Dorchester Logistics - Egeria Mine Permit Modification - Revisions.

Please find attached several revised documents on the Dorchester Logistics - Egeria mine, mine permit modification.

**SUPPORT INFORMATION TO MINING FORM MR-1300
APPLICATION TO MODIFY A MINE OPERATING PERMIT AND/OR RECLAMATION PLAN
DLI Plantation Egeria Mine – Mine Permit No. I-002170**

DLI Plantation Egeria Mine

Mine Map

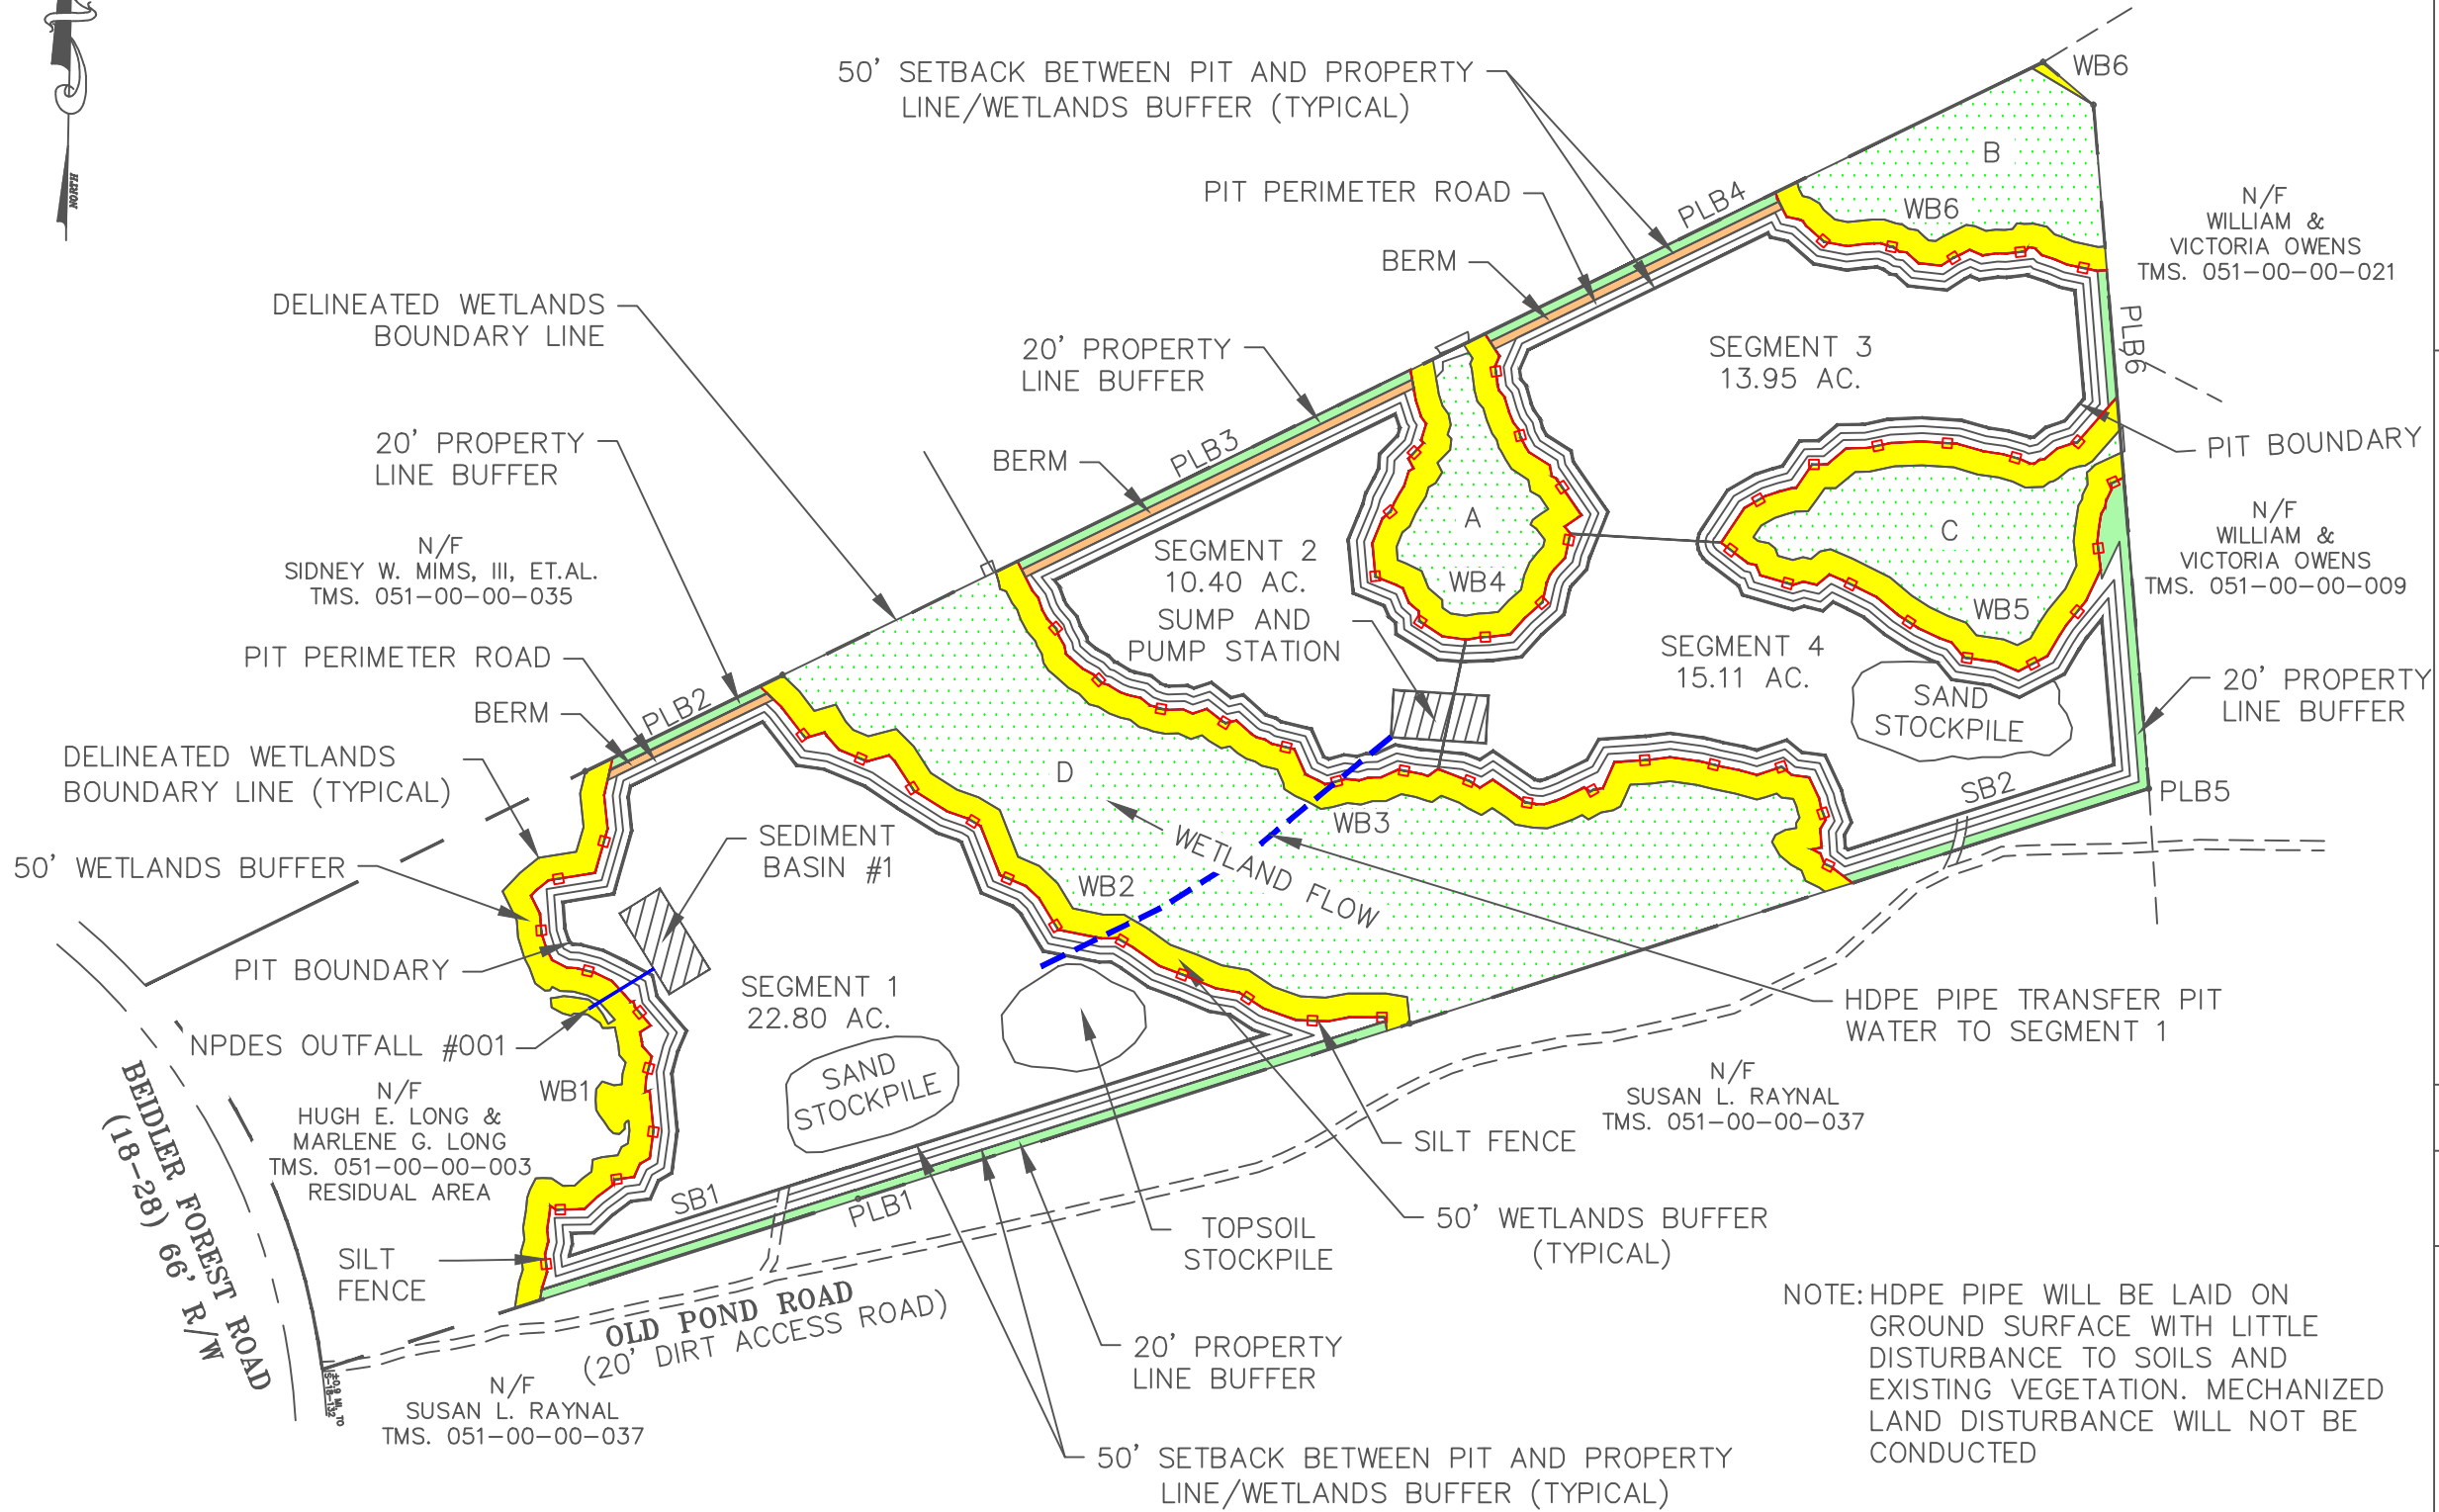
The planned sediment basin in segment 2 has been changed to a mine sump where a pump will transfer water from segments 2 - 4 to segment 1 for enhanced sediment control.

NOTE: HDPE PIPE WILL BE LAID ON GROUND SURFACE WITH LITTLE DISTURBANCE TO SOILS AND EXISTING VEGETATION. MECHANIZED LAND DISTURBANCE WILL NOT BE CONDUCTED

No.	Revision	Date	By
1	Add berms on north boundary	3/1/21	RCK
2	Remove sediment basin 2; add pipeline	3/1/21	RCK
Project No. KCS 20-132		Date: 7-20-20	
Approved by: RCK		Drawn by: BC	
Sheet No. 1 of 2
